Access Compliance Report

Public Rights-of-Way

Intersection ID: N/A	Main Street: TRYON_ST	Cross Street: PARKAIRE_LN	Location: NW
ADA ID: B6B8B883C5F5	Ramp Type: Directional1	Initial Pass/Fail: Fail	Overall Compliance: No
Severity Score: 12.5			
Codes/Mitigation Info/Possible Solution		Field Measurements/Component Compliance

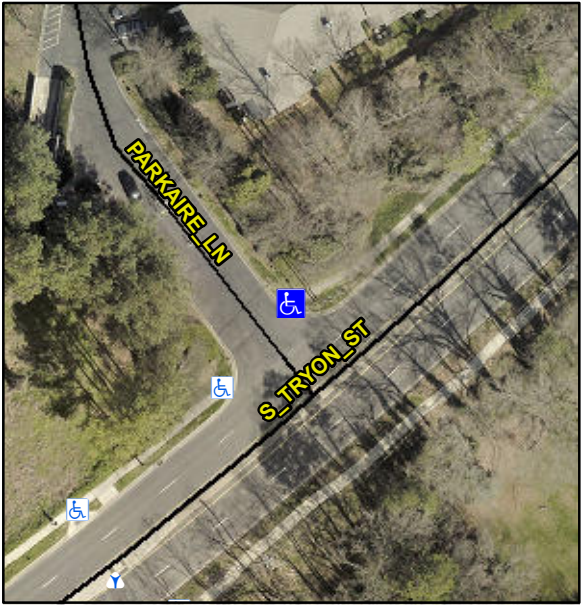
Possible Solutions:						
	Remove & Replace Entire Ramp.						
	Surveyor Notes: N/A	Compliance	Description	Data	Compliance	Description	Data
		N/A	Ramp Length (in)	62.0	N/A	Grade Break?	N/A
		Yes	Ramp Width (in)	60.0	N/A	Grade Break Slope (%)	0.0
		Yes	Ramp Slope (%)	7.7	N/A	Grade Break XSlope (%)	0.0
		No	Ramp XSlope (%)	6.2			
		N/A	Flare Type LT	N/A	N/A	Flare Type RT	N/A
		N/A	Flare Slope LT (%)	N/A	N/A	Flare Slope RT (%)	0.0
		N/A	Flare Traversable LT?	N/A	N/A	Flare Traversable RT?	N/A
		N/A	Landing Length (in)	0.0	N/A	DWS Provided?	N/A
		N/A	Landing Width (in)	0.0	N/A	DWS Contrast?	N/A
	PROW/ADA: R304.5.3	N/A	Landing Slope (%)	0.0	N/A	DWS Length (in)	N/A
		N/A	Landing X Slope (%)	0.0	N/A	DWS Full Width?	N/A
		N/A	Landing Curb? (Y/N)	N/A	N/A	DWS Offset LT (in)	N/A
		N/A	Shared Landing?	N/A	N/A	DWS Offset RT (in)	N/A
		N/A	Gutter Ponding?	0.0	N/A	Gutter Slope (%)	N/A
		N/A	Gutter Lip Ht (in)	0.0	N/A	Gutter X Slope (%)	N/A
